This document was prepared by Yong Kim and Geoff Garner.

Revision 6, September 9, 2011

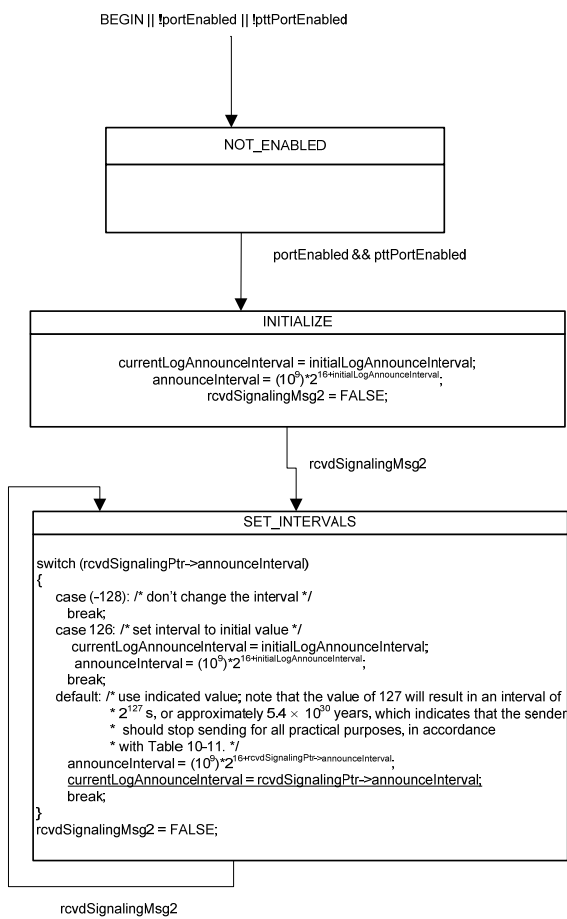
- 7) If the portPriorityVector was received in an Announce message and announce receipt timeout, or sync receipt timeout with gmPresent TRUE, have not occurred (infoIs == Received), the gmPriorityVector is not now derived from the portPriorityVector, the masterPriorityVector is not ~~higher-better~~ than the portPriorityVector, and the sourcePortIdentity component of the portPriorityVector does not reflect another port on the time-aware system, selectedRole[j] is set to PassivePort and updtInfo is set to FALSE.

- 8) If the portPriorityVector was received in an Announce message and announce receipt timeout, or sync receipt timeout with gmPresent TRUE, have not occurred (infoIs == Received), the gmPriorityVector is not now derived from the portPriorityVector, the masterPriorityVector is not ~~higher-better~~ than the portPriorityVector, and the sourcePortIdentity component of the portPriorityVector does reflect another port on the time-aware system, selectedRole[j] is set to PassivePort and updtInfo is set to FALSE.

<<Editor's Note: A user has suggested combining (7) and (8) above. The only difference in the conditions is that in (7) the sourcePortIdentity component of the portPriorityVector does not reflect another port on the time-aware system, while in (8) the sourcePortIdentity component of the portPriorityVector does reflect another port on the time-aware system. However, in both cases (i.e., in both (7) and (8)), selectedRole[j] is set to PassivePort.

(7) and (8) could be combined to a single statement, which would read:

“If the portPriorityVector was received in an Announce message and announce receipt timeout, or sync receipt timeout with gmPresent TRUE, have not occurred (infoIs == Received), the gmPriorityVector is not now derived from the portPriorityVector, and the masterPriorityVector is not better than the portPriorityVector, selectedRole[j] is set to PassivePort and updtInfo is set to FALSE.”

The reason (7) and (8) are written as separate conditions is that they appeared as separate conditions in updtRolesTree() in IEEE 802.1D-2005 (p. 169, items (j) and (k)), and are separate conditions in IEEE 802.1Q-2011 (p. 378, items (l) and (m)). However, they are separate items in 802.1D-2005 and 802.1Q-2011 because in the formulation of RSTP in those documents a distinction is made between an AlternatePort (item (j) in 802.1D-2005 and item (l) in 802.1Q-2011) and a BackupPort (item (k) in 802.1D-2005 and item (m) in 802.1Q-2011). However, in the BMCA formulation in 802.1AS, the port role is set to PassivePort in both cases. Therefore, it is not strictly necessary to have items (7) and (8) as separate conditions; they could be combined as indicated above.

However, if items (7) and (8) are kept as separate conditions, the formulation of BMCA in 802.1AS is not incorrect; it is simply not as efficient as it might be. In this sense, combining these statements might not be appropriate for the corrigendum, since the purpose of the corrigendum is to fix bugs. However, they could be combined in the 802.1AS amendment, which is planned to be worked on concurrently with the corrigendum.

Therefore, it needs to be decided whether to (A) combine items (7) and (8) in the 802.1AS corrigendum, (B) combine items (7) and (8) in the 802.1AS amendment, or (C) leave items (7) and (8) as is. >>

Figure 11-2 – Transport of time-synchronization information

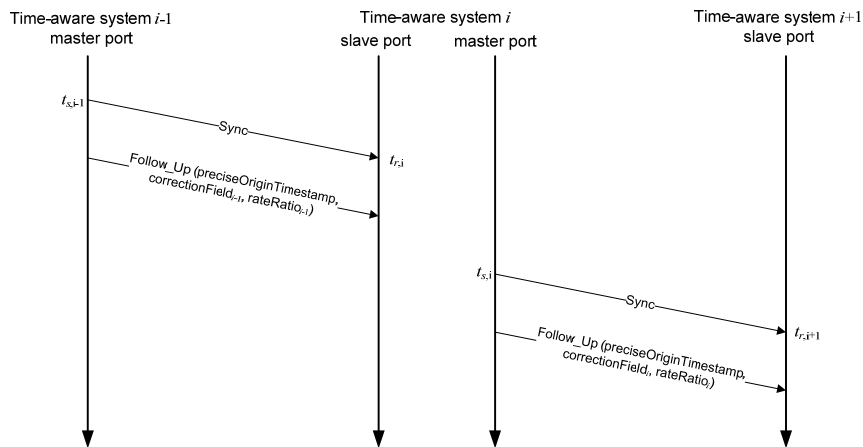
Change the Text of 11.1.3, as shown

The mean propagation delay on the link between time-aware systems $i-1$ and i , relative to the LocalClock entity of time-aware system $i-1$, is equal to neighborPropDelay (see 10.2.4.7). This must be ~~divided~~ multiplied by rateRatio_{i-1} to express it in the grandmaster time base. The total propagation delay is equal to the mean propagation delay plus the quantity delayAsymmetry (see 8.3 and 10.2.4.8); delayAsymmetry is already expressed in the grandmaster time base. The residence time, $t_{s,i} - t_{r,i}$, must be multiplied by rateRatio_i to express it in the grandmaster time base.

Figure B.3 – PTPDEV limit corresponding to wander generation requirement of Figure B.1

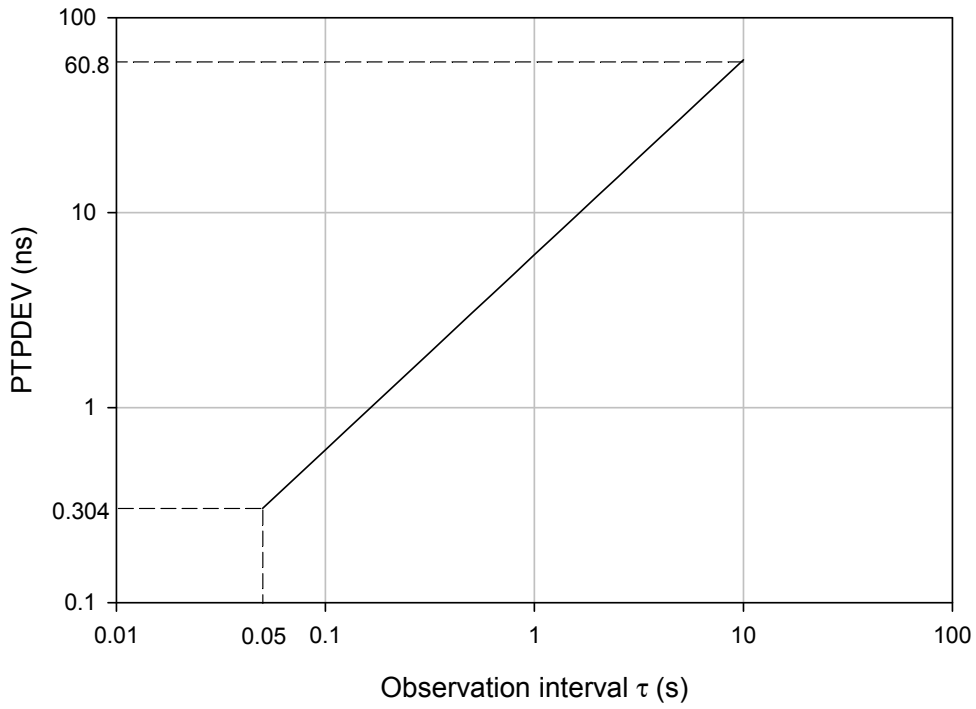
PTPDEV, denoted $\sigma_{PTP}(\tau)$, is estimated from a set of measurements, as shown in Equation (B.3):

$$\sigma_{PTP}(\tau) = \sqrt{\frac{1}{6n^2(N-2n)} \sum_{i=1}^{N-2n} (x_{i+2n} - 2x_{i+n} + x_i)^2}, \quad n = 1, 2, \dots, \left\lfloor \frac{N-1}{2} \right\rfloor$$

$$\sigma_{PTP}(\tau) = \sqrt{\frac{1}{6(N-2n)} \sum_{i=1}^{N-2n} (x_{i+2n} - 2x_{i+n} + x_i)^2} \quad n = 1, 2, \dots, \left\lfloor \frac{N-1}{2} \right\rfloor$$
